Planning Decisions Committee Meeting

Property	316 & 324-328 Napier Street Fitzroy VIC 3065
Ward	MacKillop
Application	PLN24/0164
Proposal	Demolition of existing buildings; construction of a five-storey building (and basement) containing 8 dwellings; construction of a vehicle crossover; associated use of the land for dwellings; and a reduction of the visitor bicycle parking requirements of Clause 52.34
Zoning & Overlay/s	<ul style="list-style-type: none"> - Commercial 1 Zone - Development Contributions Plan Overlay (Schedule 1) - Design and Development Overlay (Schedule 10 – Johnston Street Precinct – west of Smith Street) - Design and Development Overlay (Schedule 36 – Fitzroy East and Johnston Street North) - Heritage Overlay (HO334 – South Fitzroy Precinct) - Environmental Audit Overlay
Strategic setting	Designated 'High Change Area' and within the Johnston Street Neighbourhood Activity Centre
Submissions	22 objections and 0 submissions in support

Figure 7 – Sightlines from opposite side Argyle Street demonstrating approximate extent of visible built form of proposed development and result of condition to delete the proposed fourth storey.

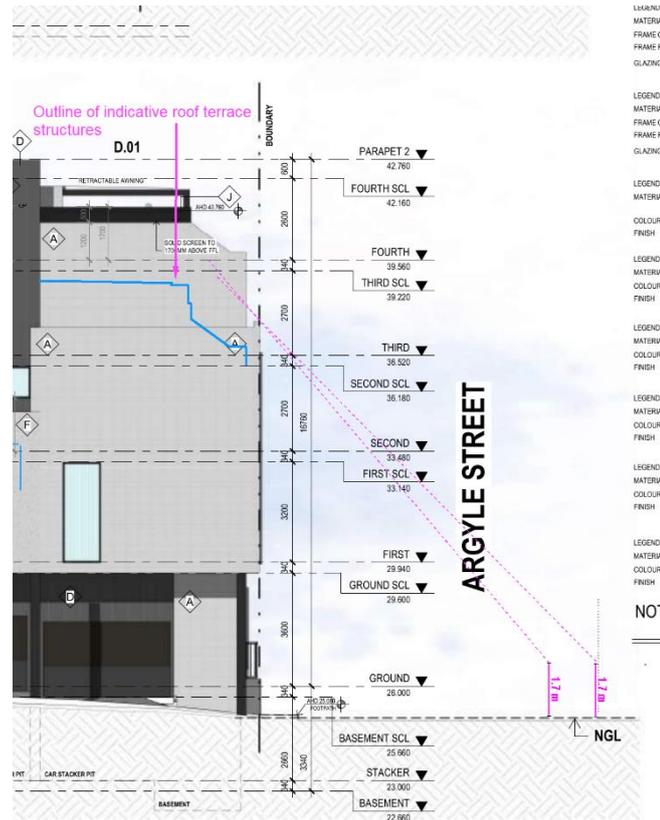
80. This would result in the loss of a bedroom and associated amenities but would retain the roof terrace (the dwelling would become a two bedroom dwelling). A diagram illustrating this change is below – it shows sightlines from the opposite footpath of Argyle Street with an indicative outline of the built form to the roof terrace transposed to the third floor as a result of the condition.

81. This change would provide an acceptable outcome given that:
 - (a) There would be a significant reduction and downward transition towards the Argyle Street interface that would be evident both from Napier Street and Argyle Street;

Figure 8 – Section A-A from decision plans with 6m setback above maximum street wall added in pink to demonstrate indicative extent of non-compliant built form of upper level.

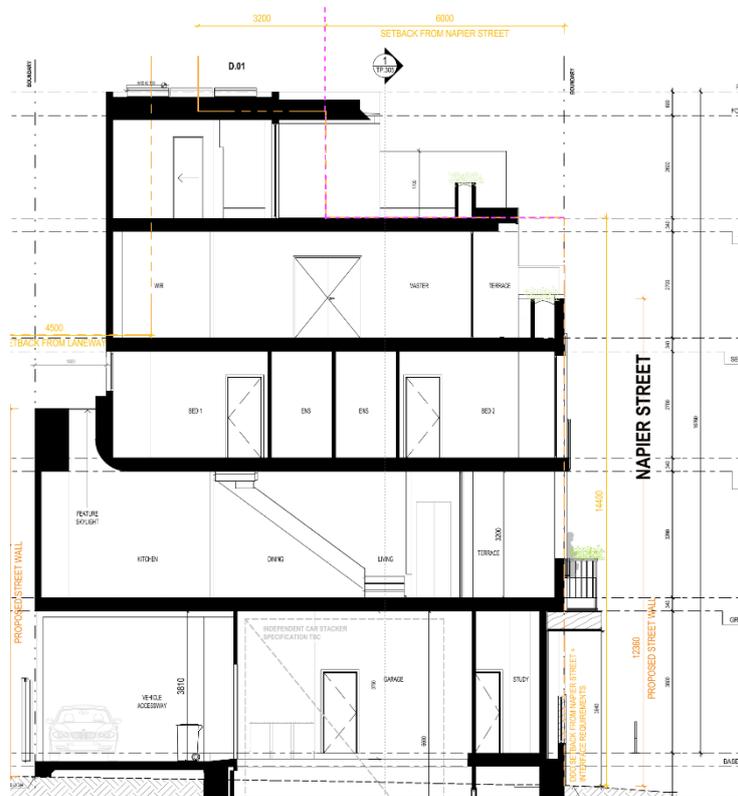
- 86. In terms of the upper level setback, as illustrated by the Figure 8 below, the portions of built form projecting into the minimum 6m setback are not substantial. Officer analysis suggests that visible built form associated with the top floor would be limited, when viewed from the opposite (western) side of the footpath to Napier Street as the third floor canopy to balconies would block much of this level.

Figure 2: Plan of D.01 level 1. Stairs and lift programmed on north wall.

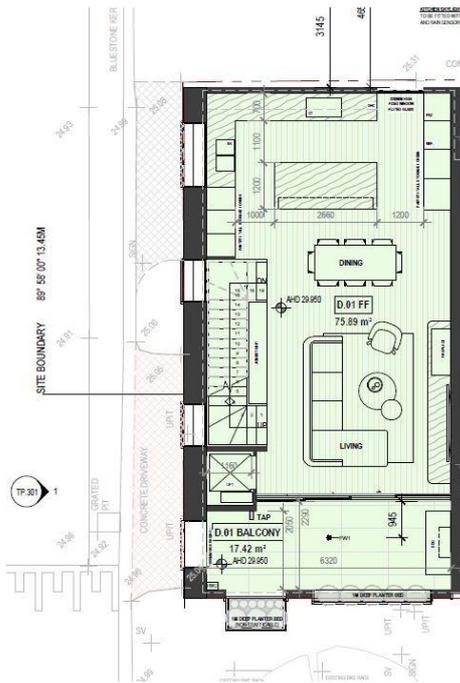
- The interface to argyle Street has suffered somewhat by the fronting of D.01 towards Napier rather than Argyle. Typically in sets of townhouse occupying a corner site the terminating dwelling in the row will be orientated to front the return street. This creates a more integrated street frontage with fenestration and articulation to this 'return' street. In this case with D.01 facing Napier and internal programming of stairs and lifts on the north wall, this has not been achieved.

- The presentation of a relatively blank north wall to Argyle Street has resulted in a lesser architectural and urban design outcome.
- It is recommended that the layout of D.01 is rotated to address Argyle Street as much as Napier Street presenting a façade more similar to that presented to Napier.
- Alternatively, the applicant may want to consider alternate uses for the part of the site currently occupied by D.01. For instance, a commercial use with a ground floor retail and upper level small offices may more easily produce a more desirable public realm outcome at the corner. An activated edge here would better integrate the overall proposal with the surrounding streetscape and produce a stronger urban design outcome.

Figure 3: Proposed visitor parking shown in the public realm.

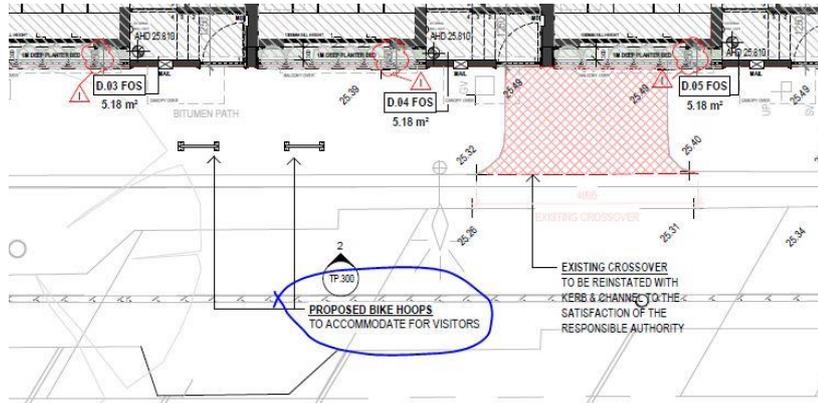
- The design shows visitor bicycle parking included in the public realm:

Figure 1: Argyle Street – street wall height and upper-level setback

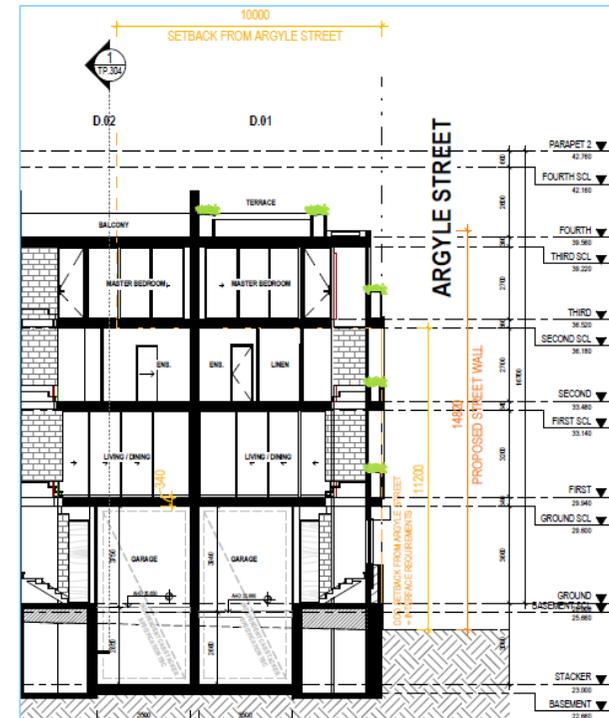
The proposed upper-level setbacks are noted as 'slight setback of between 0.3 metres and 2.2 metres to Argyle and Napier Streets respectively with this increasing to 7.1 metres and 4.5 metres for the top floor, noting that the development provides a sloping wall treatment to the latter.'

It is noted that whilst the Argyle Street upper-level setback could be considered in compliance with the requirements if the street wall height is accepted as there is no level above the proposed streetwall height, this streetwall height exceeds the preferred requirements within interim and draft DDO36 (see *figure 1*).

Figure 2: Napier Street – street wall height and upper-level setback & rear interface - street wall height and building separation

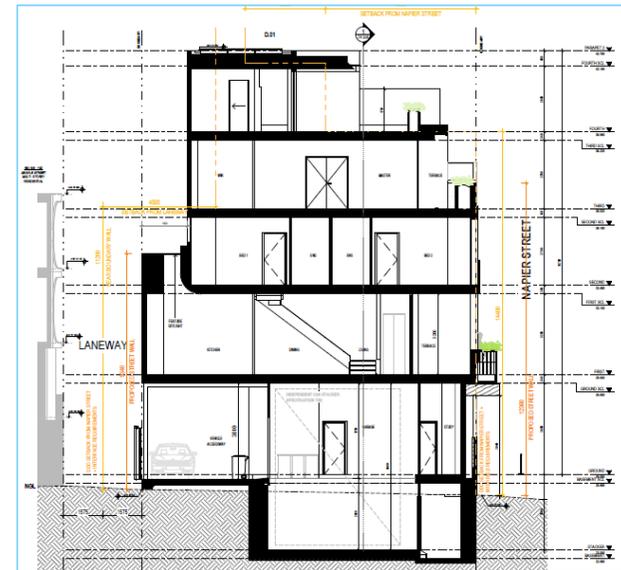
Additionally, whilst Napier Street does not comply with the upper-level requirements, the streetwall height is within the preferred requirements within interim and draft DDO36. This could be considered in compliance with the requirements as it would sit within the proposed envelope (see *figure 2*).

Interim and draft DDO36 propose an 11.2m rear boundary wall requirement to limit the impact on the amenity of existing dwellings. The application proposes a 9.34m rear streetwall interface with the laneway to the east of the site. This wall height is considered appropriate given the narrow (3.15m – seen in *Figure 2*) width of the laneway that separates the proposed site from the development to the east.

Figure 3: South interface – Building separation

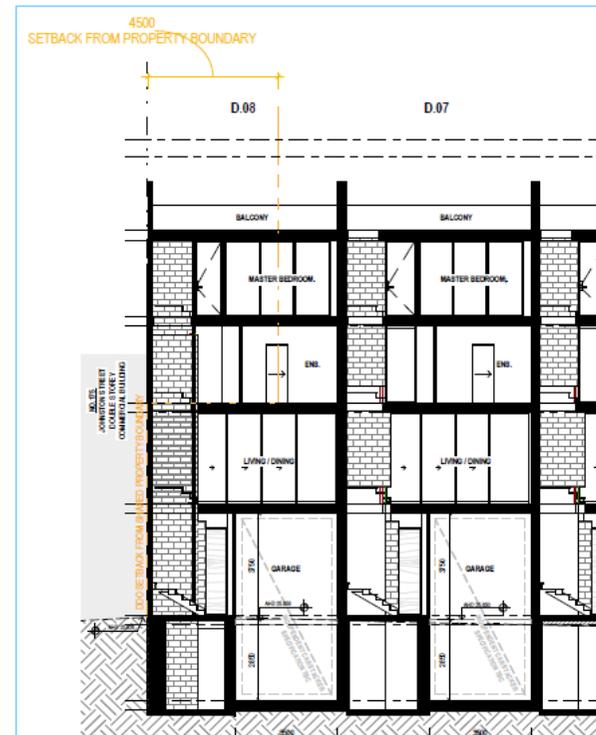
The proposal does not adequately provide building separation from the residential property at 160-162 Argyle Street and the commercial property at 175 Johnston Street, Fitzroy (see *figure 3*).

As seen in *Figure 2* and *Figure 3*, the rear separation is not sufficient. The proposal doesn't comply with the equitable development objectives within interim DDO36 outlined in *Clause 1.0 Design Objectives* of DDO36. The lack of building separation in addition to the proposed streetwall heights and upper-level setbacks is not considered appropriate for the site.

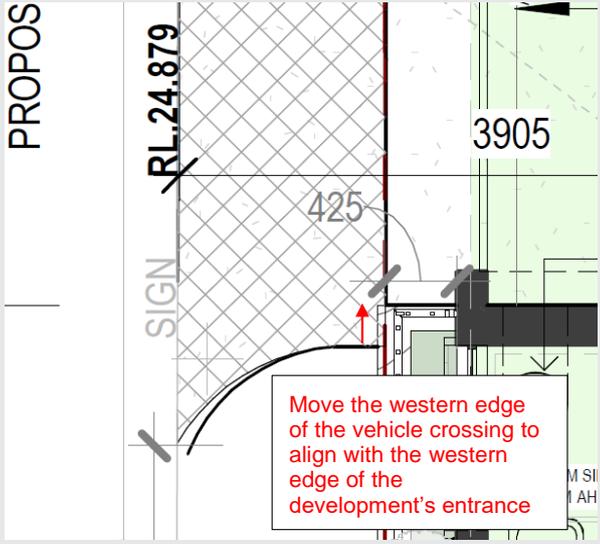
Bicycle Hoops – Napier Street	The Engineering unit do not support the proposed bicycle hoops outside of the development in Napier Street.

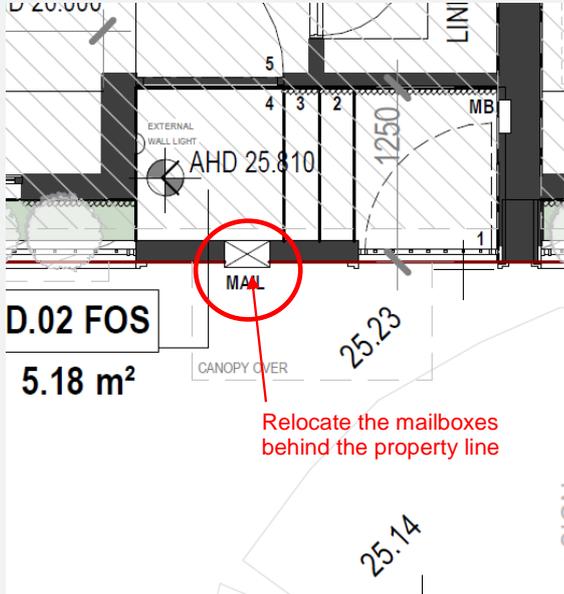
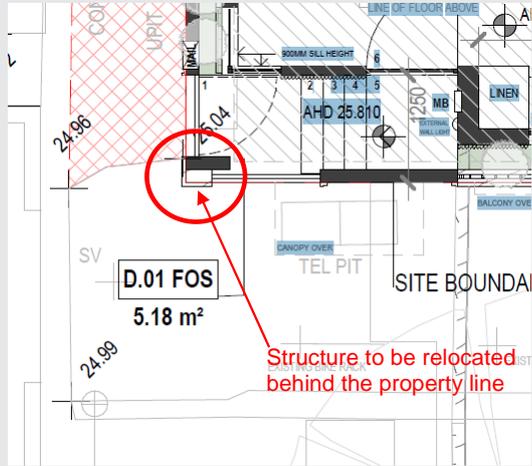
Width of Vehicle Crossing	The applicant to align the western edge of the vehicle crossing with the western edge of the vehicle entrance.

Item	Details
<p>Mailboxes</p>	<p>The applicant to setback the mailboxes behind the property line along the Napier Street and Argyle Street frontages.</p>  <p>Relocate the mailboxes behind the property line</p>
<p>Structure on the North-West Corner of Site – Ground Floor</p>	<p>The applicant to setback the structure located on the north-west corner of the site (on the ground level) behind the property line.</p>  <p>Structure to be relocated behind the property line</p>
<p>Bicycle Hoops – Napier Street</p>	<p>The applicant to delete on the drawings the proposed bicycle hoops on Napier Street.</p> <p>Bicycle hoops associated with the development must be provided inside the property.</p>
